Editors: update Figure 100-3 to the following: summary of changes: removal of scrambler and gearbox from PCS, removal of interleaver and OFDM framer in PMA, expansion of symbol mapper and frame timing boxes, added staging to pilot insertion box, added new error from PHY Link to staging and pilot insertion box.

Editors: change subclause of 101.4.3.8 to Staging and Pilot Insertion. Move old 101.4.3.8 to 101.4.3.8.1. Add new text after 101.4.3.8 for Staging.

Figure 101-3—Framing Timing

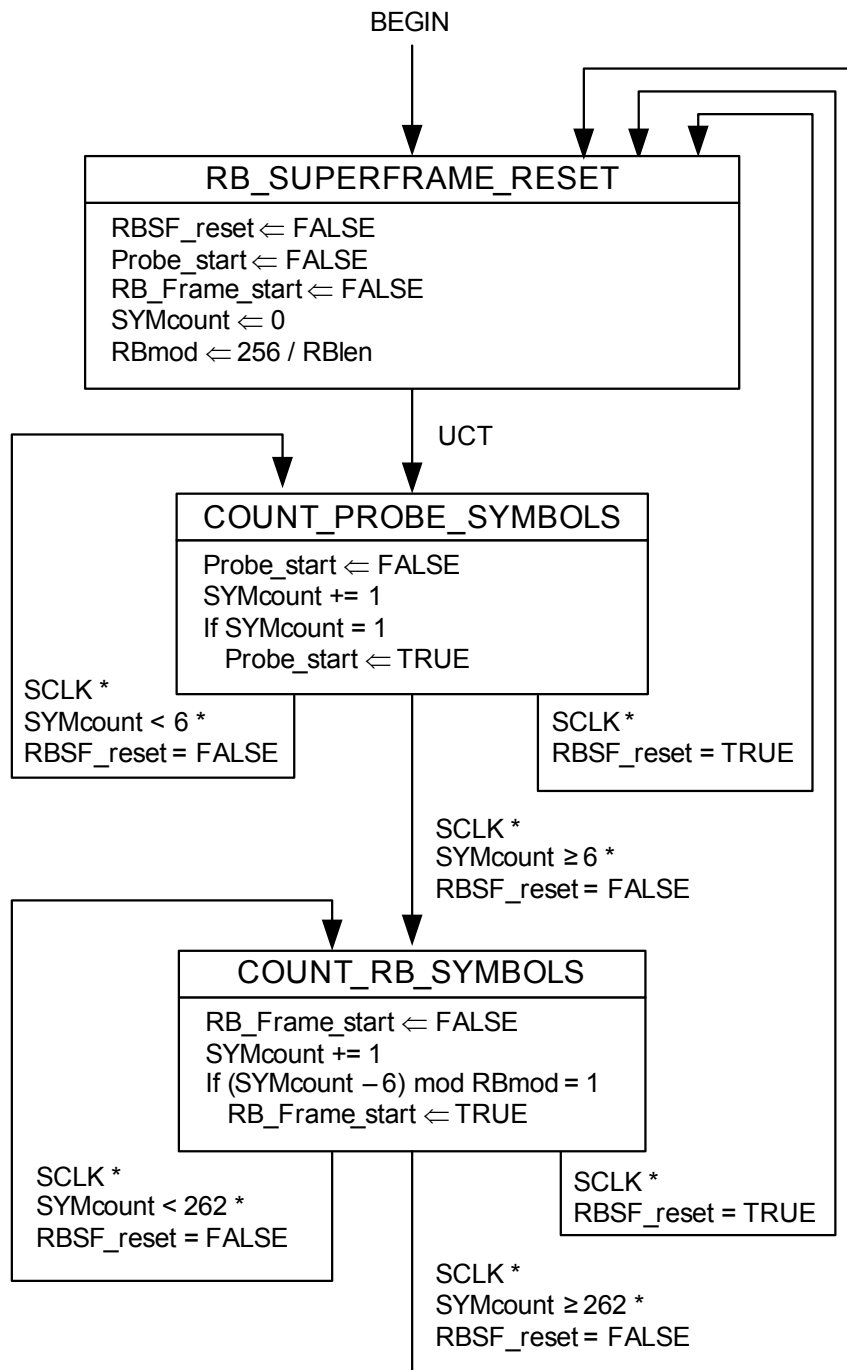
Editors: Create new subclause 101.4.3.3 and move existing 101.4.3.3 to 101.4.3.3.1. Remove 101.4.3.3.2 through 101.4.3.3.4 as this information is in other places in Clause 101. New subclauses beginning with 101.4.3.3.2 here, are new draft text. Need to update first paragraph of 101.4.3.3.1 to point to Table 101 variable table instead of Clause 45.

The CLT PMA shall implement the frame timing process as shown in Figure 101–3.
